STAFF REPORT
COMMUNITY DEVELOPMENT DEPARTMENT

HEARING: June 1, 2021
 DATE: *Continued from: March 9, April 13, and May 18, 2021*
 TO: Mayor & City Council
 FROM: Sonya Allen, Associate Planner
 208-884-5533
 SUBJECT: H-2020-0117
 Shafer View Terrace – AZ, PP
 LOCATION: East side of S. Meridian Rd./SH 69, midway between E. Amity Rd. and E. Lake Hazel Rd., in the SW ¼ of Section 31, T.3N., R.1E. (Parcels #R7824220044 & #R7824220042)

Annexation of a total of 40.48 acres of land with R-2 (10.66 acres) and R-4 (29.82 acres) zoning districts; and Preliminary Plat consisting of 50 buildable lots and 10 common lots on 39.01 acres of land in the R-2 and R-4 zoning districts.

B. Preliminary Plat & Phasing Plan (date: ~~11/18/2020~~ 3/9/2021)

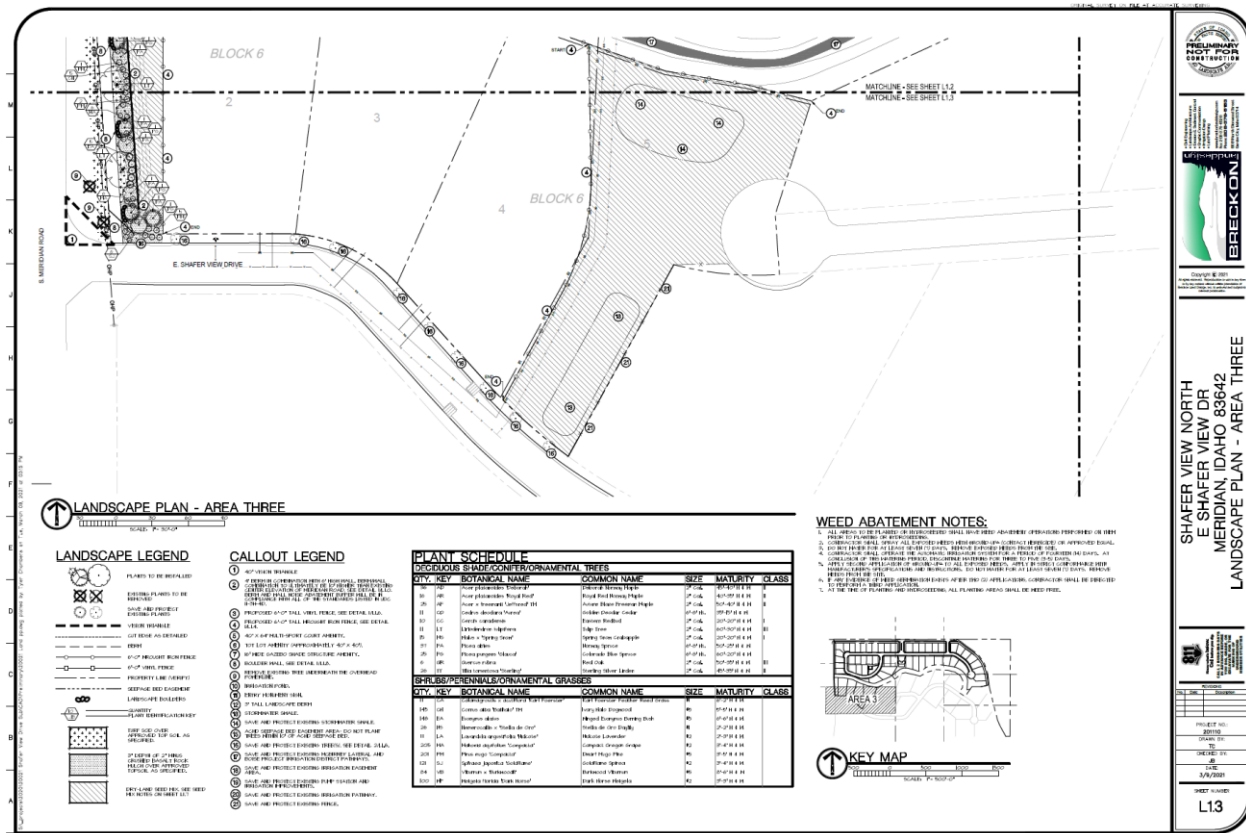
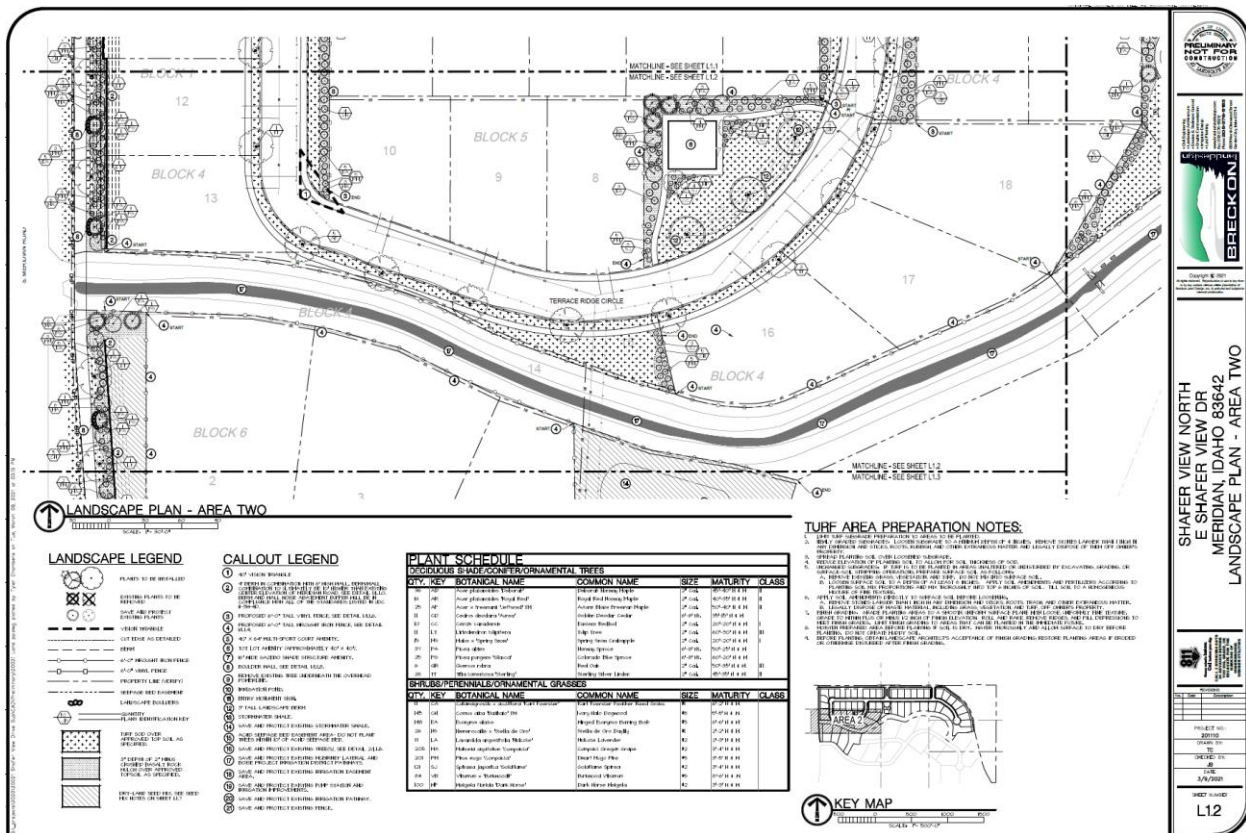
- b. Block 3 exceeds the maximum block face standards listed in UDC 11-6C-3F; the plat shall be revised to comply with these standards unless otherwise approved by City Council. *A waiver is requested from Council to exceed the maximum block face allowed of 1,200 feet to allow the block face as proposed.*

- ~~c. The 38' wide drain on the eastern portion of the site shall be contained entirely within a common lot(s). Depicted on revised plat.~~
 - ~~d. Remove one (1) buildable lot in the vicinity of Lots 2-5, Block 6 south of the McBirney Lateral. Depicted on revised plat.~~

C. Landscape Plan (date: 5/17/2020 ~~2/3/2020~~ 3/9/2021)

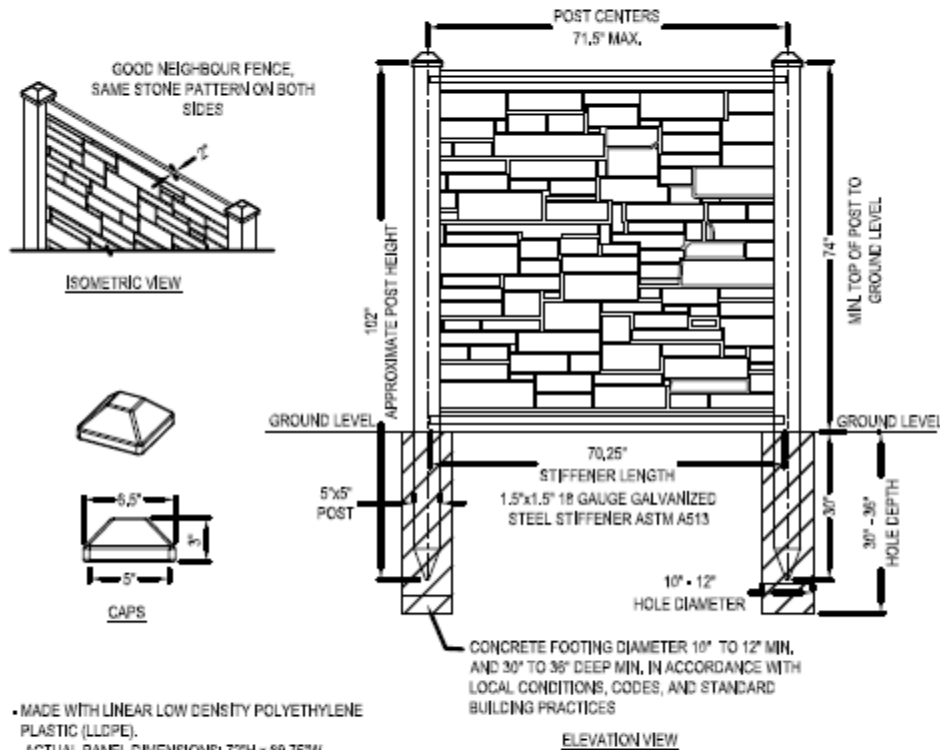
Landscaping is required adjacent to the pathway along S. Meridian Rd./SH-69 per the standards in UDC [11-3B-12C](#). A 5' wide landscape strip is required on both sides of the pathway planted with a *mix* of trees, shrubs, lawn and/or other vegetative ground cover. **The Landscape**

Requirements table should include the linear feet of pathway with the required vs. proposed number of trees to demonstrate compliance with UDC standards.

Landscaping is required within parkways per the standards listed in UDC [11-3A-17](#) and [11-3B-7C](#). **The Landscape Requirements table should include the linear feet of parkways within the development with the required vs. proposed number of trees to demonstrate compliance with UDC standards.**

A 4-foot tall berm with a 6-foot tall solid wall by Simtek is proposed along S. Meridian Rd. as noise abatement as depicted on the detail on Sheet L1.0 of the Landscape Plan. Architectural elements are proposed to break up monotonous wall planes as required. **~~A detail of the proposed wall that demonstrates compliance with the standards listed in UDC 11-3H-4D should be submitted with the final plat for the first phase of development.~~** *Depicted on the revised landscape plan.*

4. The landscape plan included in Section VII.C ~~submitted with the final plat~~ shall be revised as follows:
 - a. ~~Include calculations in the Landscape Requirements table that demonstrate compliance with the standards for pathway (11-3B-12C) and parkway (11-3B-7C) landscaping; include required vs. provided number of trees. Done~~

- c. ~~Include a detail of the berm and wall required for noise abatement along S. Meridian Rd./SH-69 that demonstrates compliance with the standards listed in UDC 11-3H-4D. Done~~
